Technical Service Bulletin: tsb100105

Released Date: 04-Feb-2004

Flexible Fuel Line

Fig. 1, Flexible Steel-Braided Fuel Line

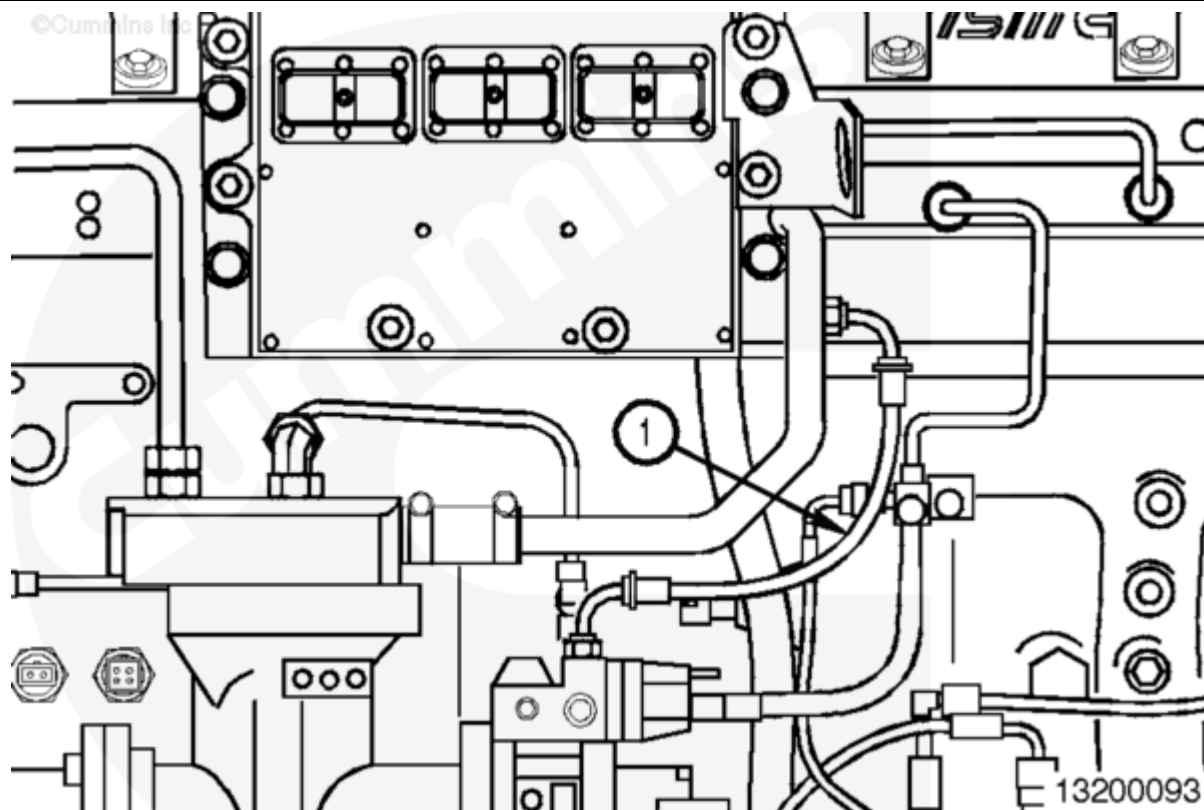
This Technical Service Bulletin introduces a new flexible steel-braided fuel line (1) for the M11 and ISM/QSM11 Series engines. This flexible fuel line supersedes the hard steel line that supplies fuel from the fuel pump to the ECM cooling plate. (See Fig. 1.)

This flexible fuel line was implemented into production with engine serial number first 35009935 on June 19, 2000.
